Access Compliance Report

Public Rights-of-Way

(Curb Ramps)

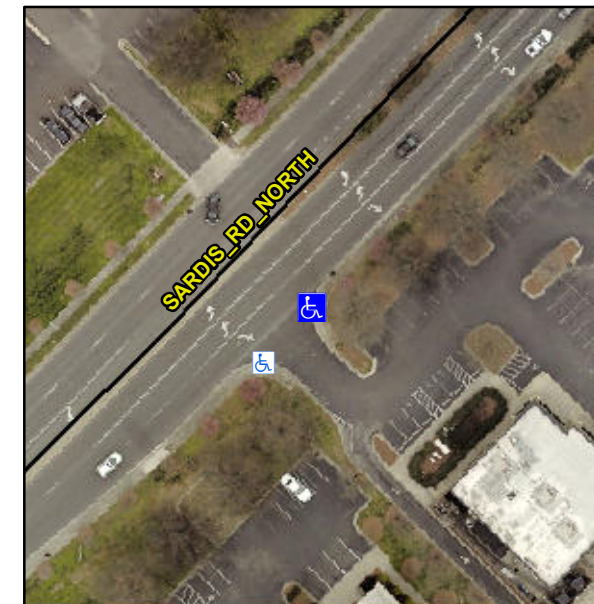
Intersection ID: 10037289	Main Street: SARDIS_RD_NORTH	Cross Street: N/A	Location: E
ADA ID: 7C636AA39A0D	Ramp Type: Perp	Initial Pass/Fail: Fail	Overall Compliance: No
Severity Score: 12.5			
Codes/Mitigation Info/Possible Solution		Field Measurements/Component Compliance

Not Found, R304.5.3

Compliance	Description	Data	Compliance	Description	Data
N/A	Ramp Length (in)	55.0	Yes	Ramp Slope (%)	8.0
Yes	Ramp Width (in)	48.0	No	Ramp XSlope (%)	5.4
N/A	Flare Type LT	N/A	N/A	Flare Type RT	N/A
N/A	Flare Slope LT (%)	N/A	N/A	Flare Slope RT (%)	N/A
N/A	Flare Traversable LT?	N/A	N/A	Flare Traversable RT?	N/A
N/A	Landing Length (in)	N/A	N/A	DWS Provided?	N/A
N/A	Landing Width (in)	N/A	N/A	DWS Contrast?	N/A
N/A	Landing Slope (%)	N/A	N/A	DWS Length (in)	N/A
N/A	Landing X Slope (%)	N/A	N/A	DWS Full Width?	N/A
N/A	Landing Curb? (Y/N)	N/A	N/A	DWS Offset (in)	N/A
N/A	Shared Landing?	N/A			
N/A	Gutter Ponding?	N/A	N/A	Gutter Slope (%)	N/A
N/A	Gutter Lip Ht (in)	N/A	N/A	Gutter X Slope (%)	N/A
N/A	Painted X Walk1?	No	N/A	Painted X Walk2?	N/A
	X Walk 1 Direction	To SW		X Walk 2 Direction	N/A
N/A	X Walk 1 Width (in)	N/A	N/A	X Walk 2 Width (in)	N/A
	X Walk 1 Slope (%)	1.1		X Walk 2 Slope (%)	N/A
	X Walk 1 X Slope (%)	3.1		X Walk 2 X Slope (%)	N/A

Remove & Replace Entire Ramp.
